ADDENDUM #1

**MSAD #72
PRE-K-8 SCHOOL AT MOLLY OCKETT
FRYEBURG, MAINE**

APRIL 22, 2015

PREPARED BY FAY, SPOFFORD & THORNDIKE

**EXCERPT OF SHEET C-1.2
ADDED REMOVAL NOTE FOR 4,000 GAL.
UNDERGROUND FUEL TANK**

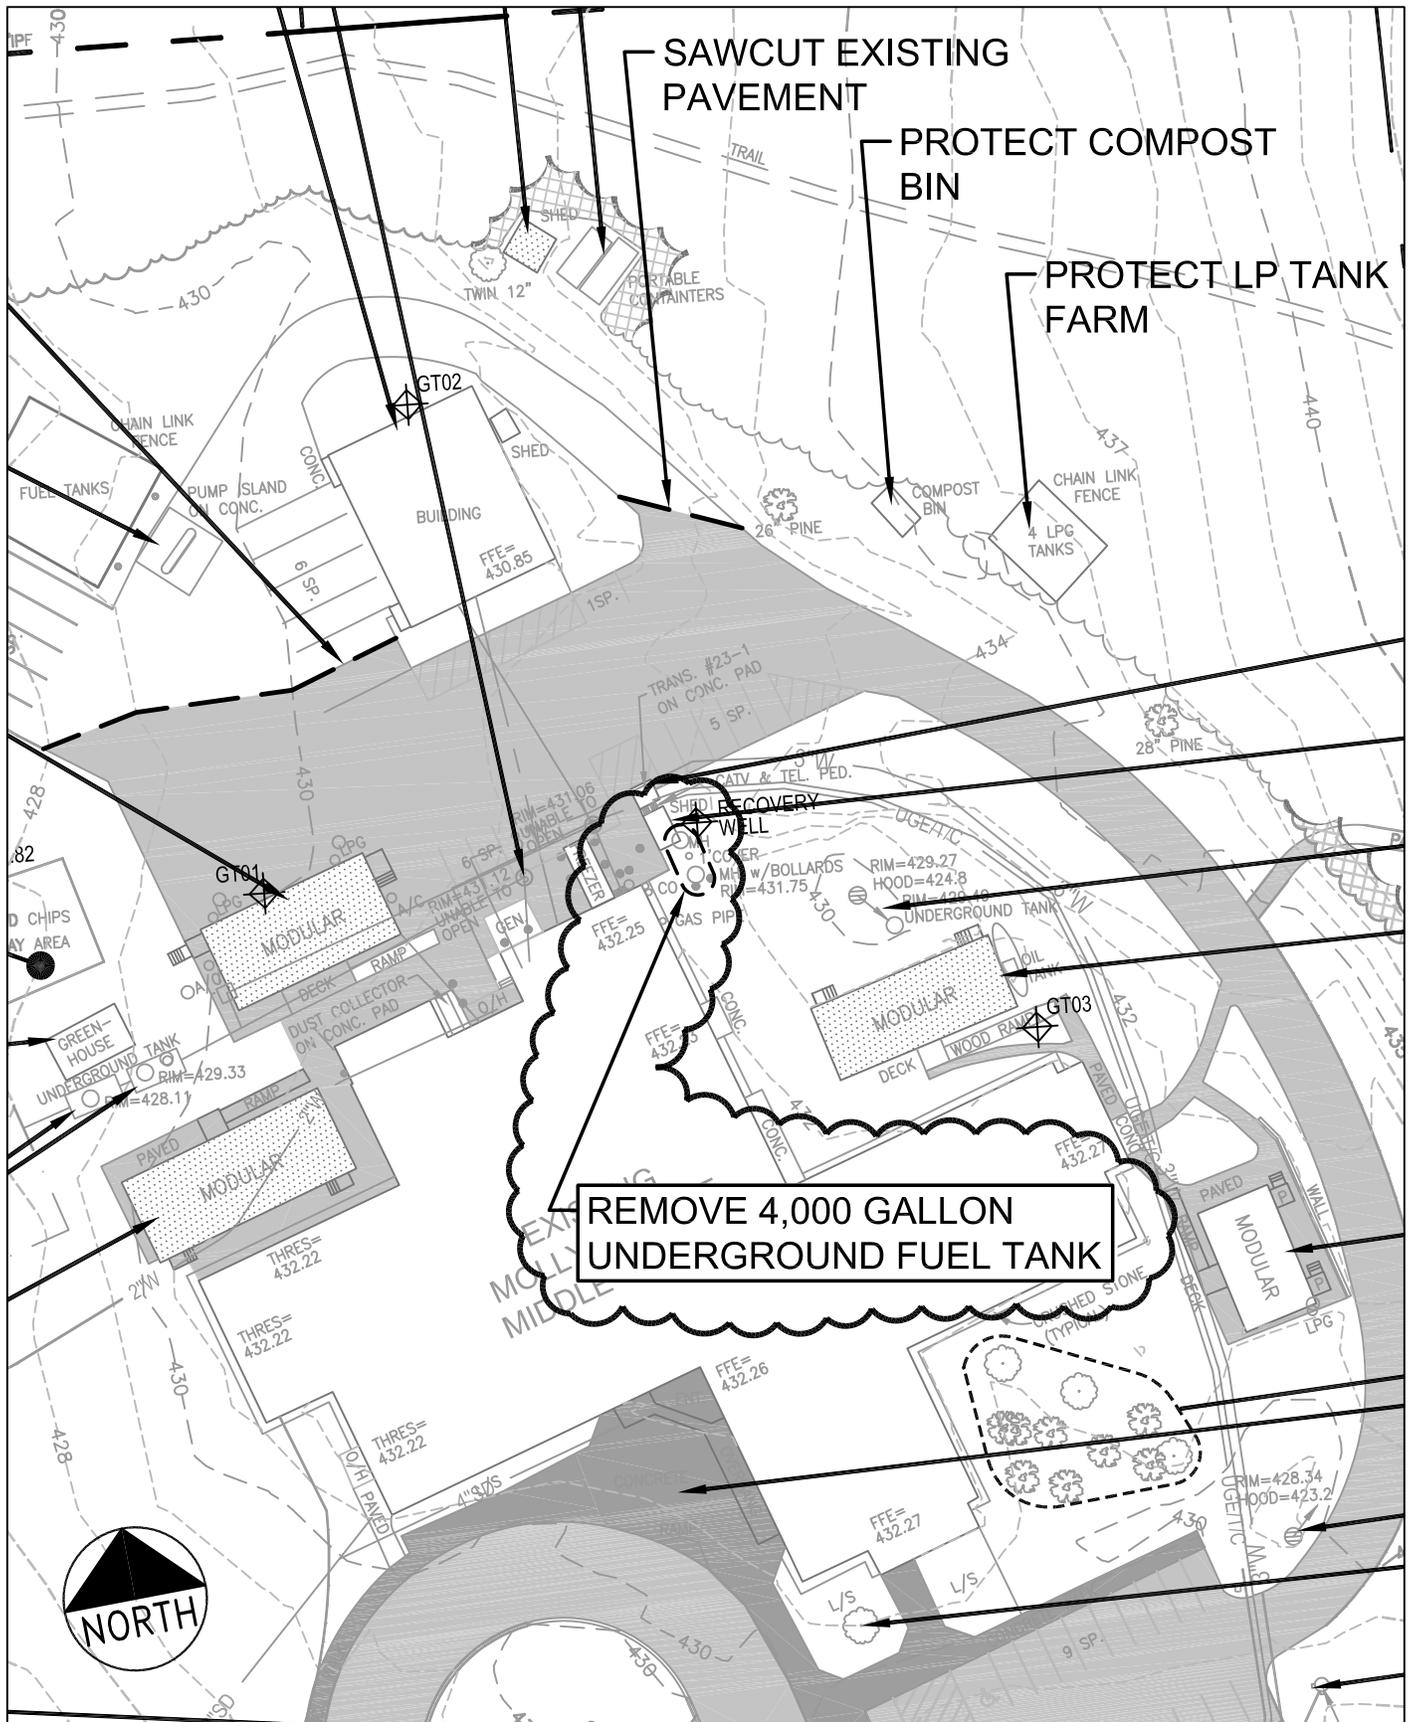
A. A 4,000 gallon underground fuel tank on the northeasterly corner of the existing school building shall be removed as part of the site work. The removal of this tank shall be performed after the heating system for the new school building is operation (anticipated to be in the fall of 2016).

The location of the underground fuel tank and notation for removal is shown on CSK-1 that is appended to this addendum.

REMOVE 4,000 GALLON UNDERGROUND FUEL TANK

**EXCERPT OF SHEET C-2.3
MODIFIED EXTENT OF PHASE 2A / 3B
ON EASTERLY SIDE OF SCHOOL**

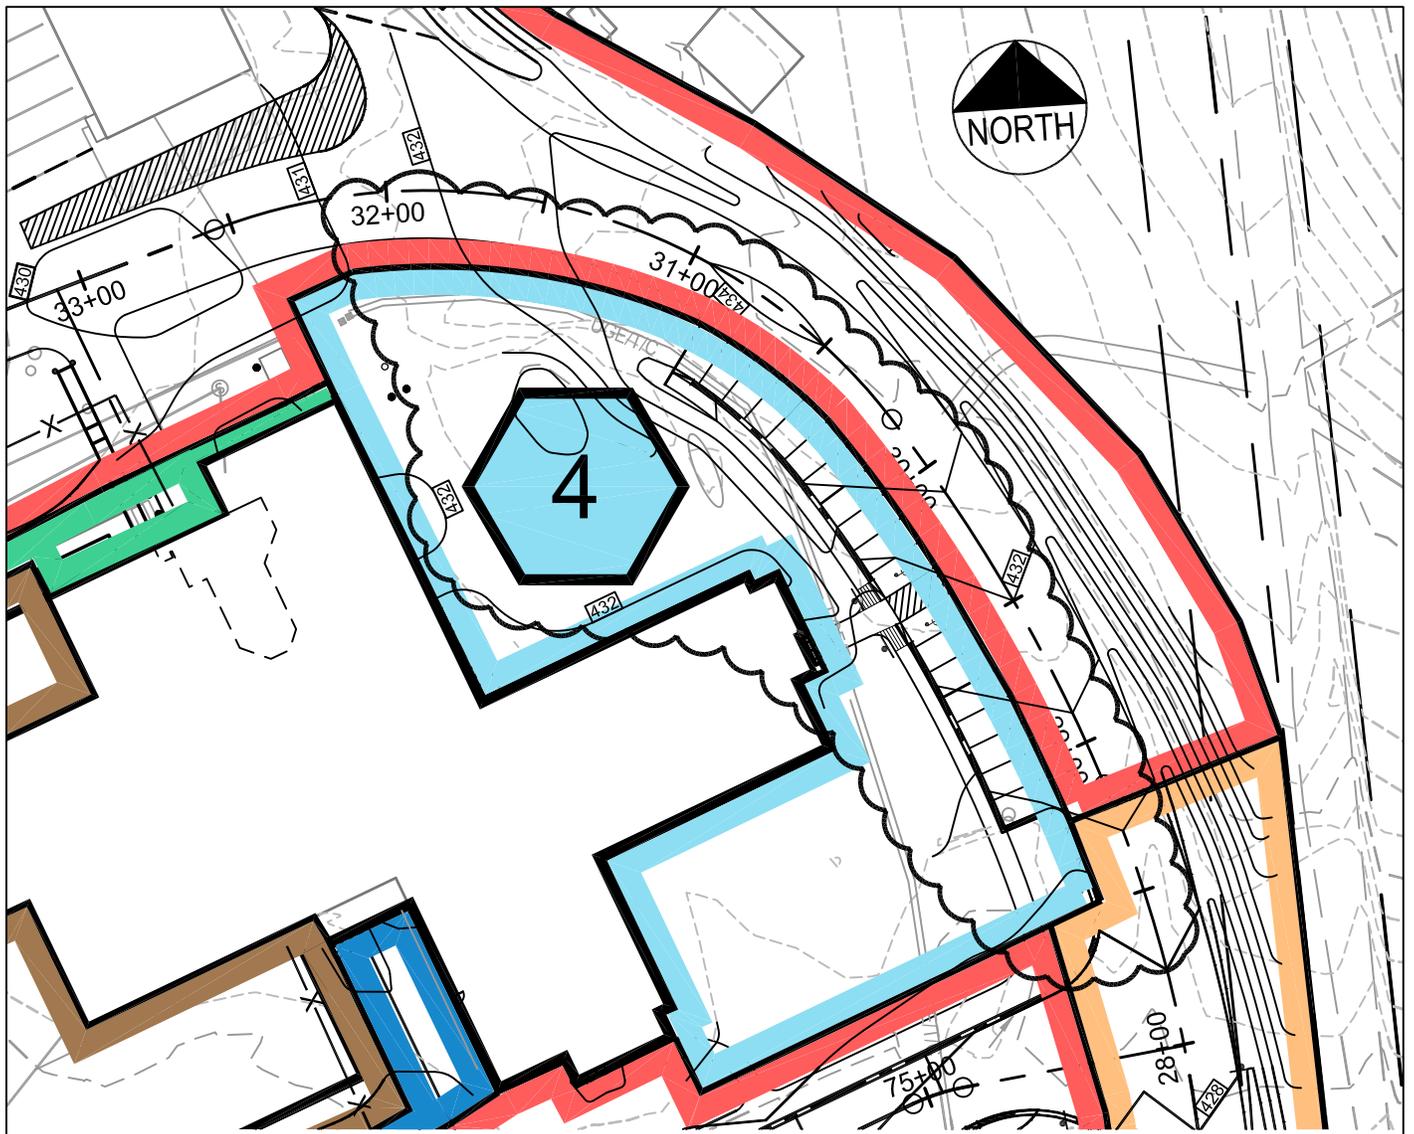
A. The 19 parking stalls and sidewalk along a portion of the access drive on the easterly side of the existing school has been shifted from Phase 2A to Phase 4. These parking stalls and sidewalk are to be constructed between July 1, 2017 and August 15, 2017 after the two modular school buildings in this area are removed from the site by the school in June 2017.

In addition, the timeline for completion of Phase 4 has been revised to be from July 1, 2017 to August 15, 2017.

The adjustments to the Construction Phasing Plan are depicted on CSK-2 that is appended to this addendum.

EXCERPT OF SHEET C-2.3
 MODIFIED EXTENT OF PHASE 3A
 AT BRIDGTON ROAD (ROUTE 302)

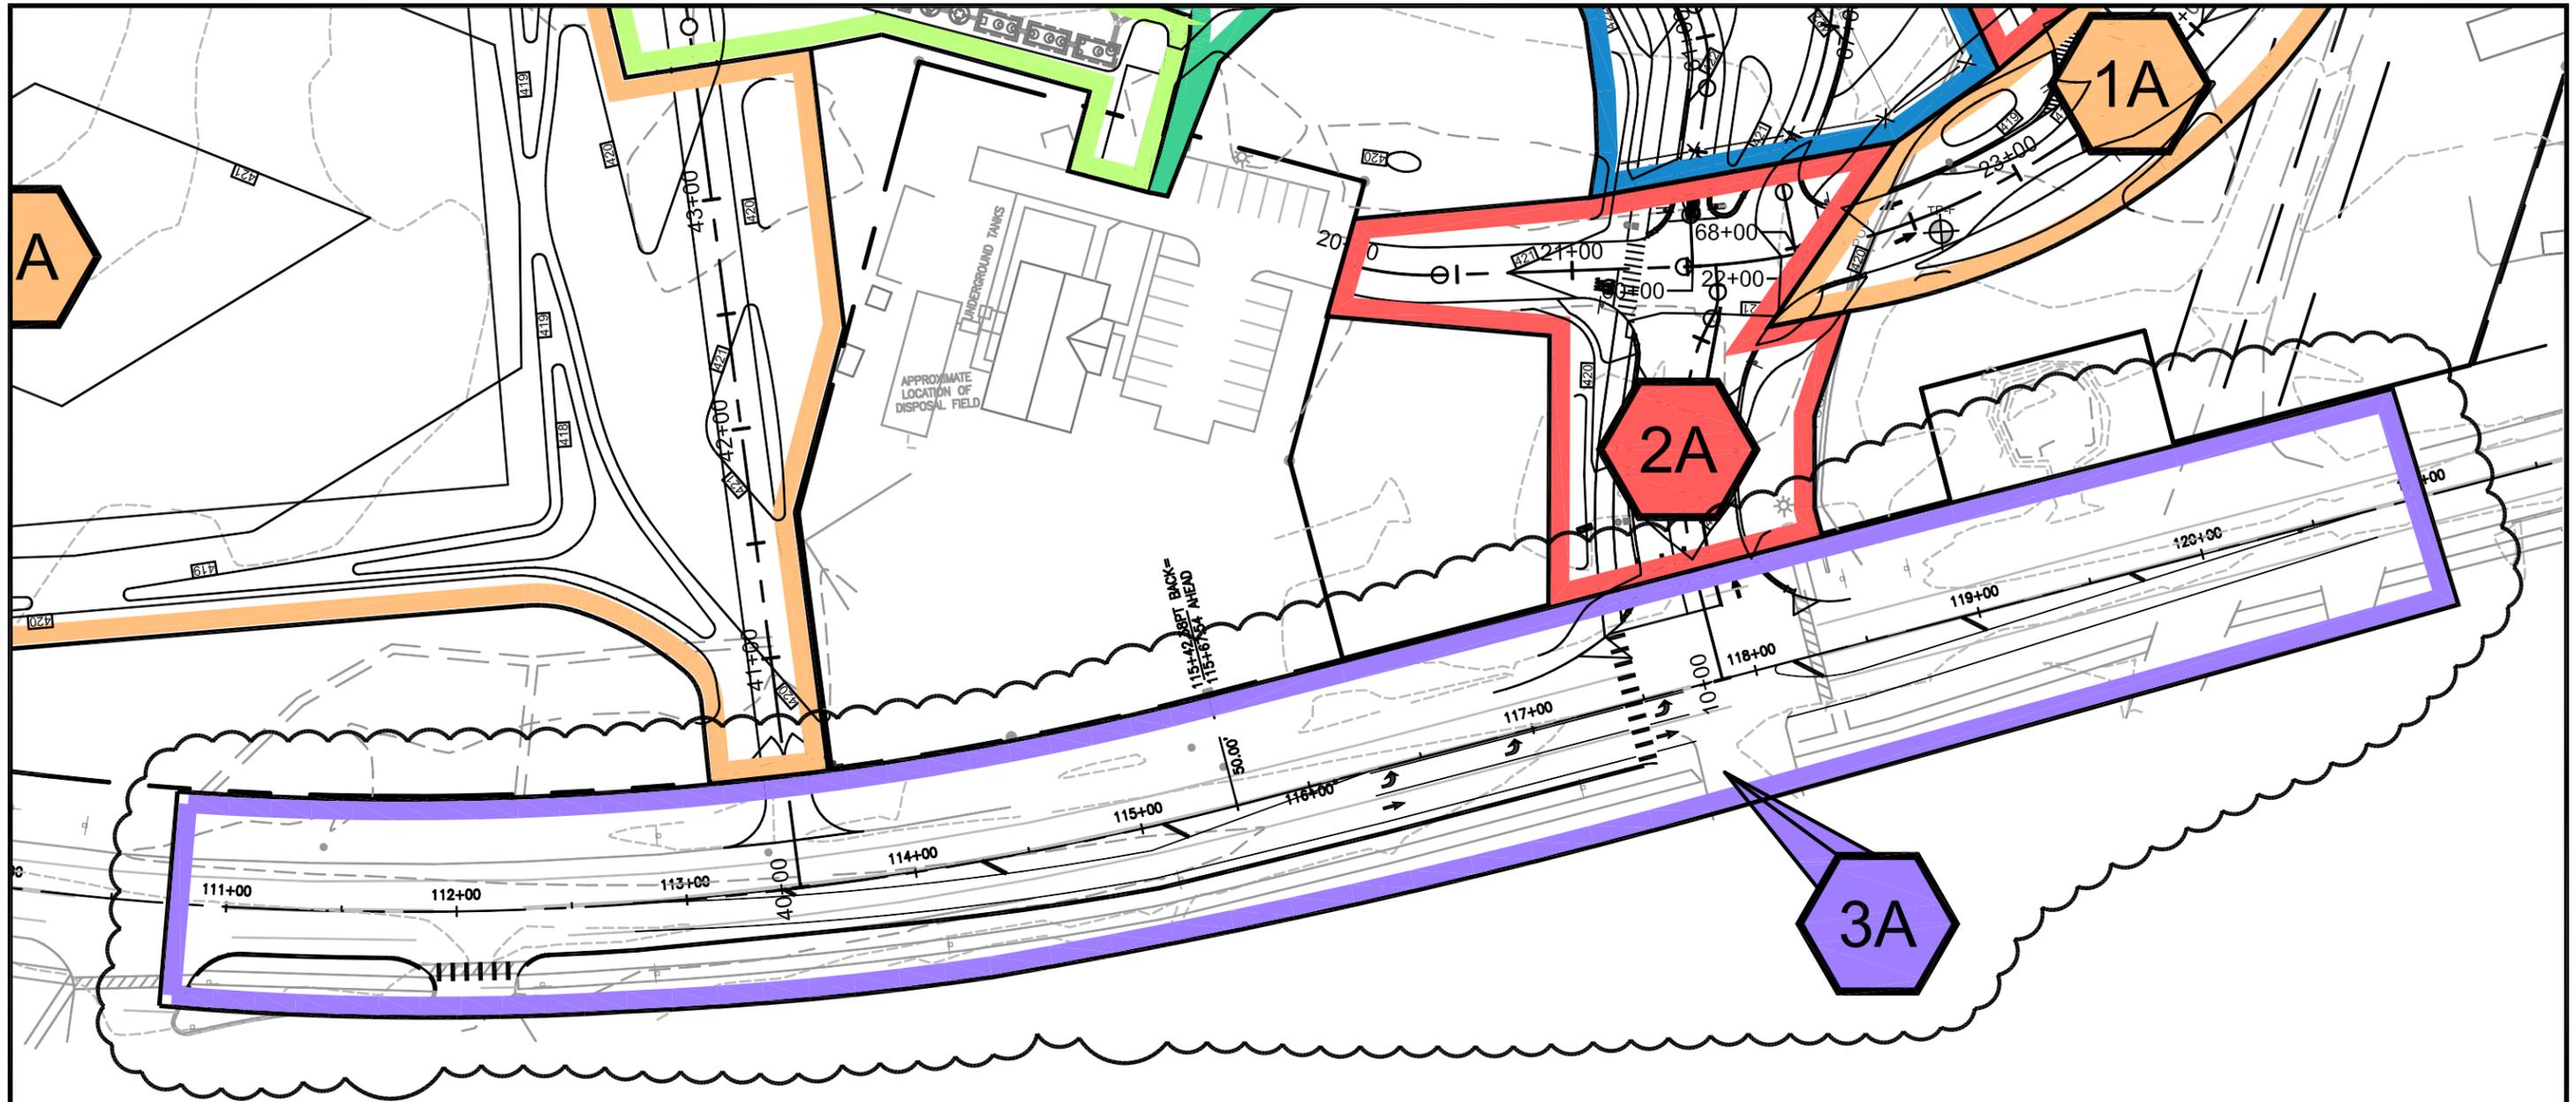
B. The extent of Phase 3A has been adjusted on the plan to match the full extent of the offsite roadway improvements. The adjustments to the Construction Phasing Plan are depicted on CSK-2 that is appended to this addendum.
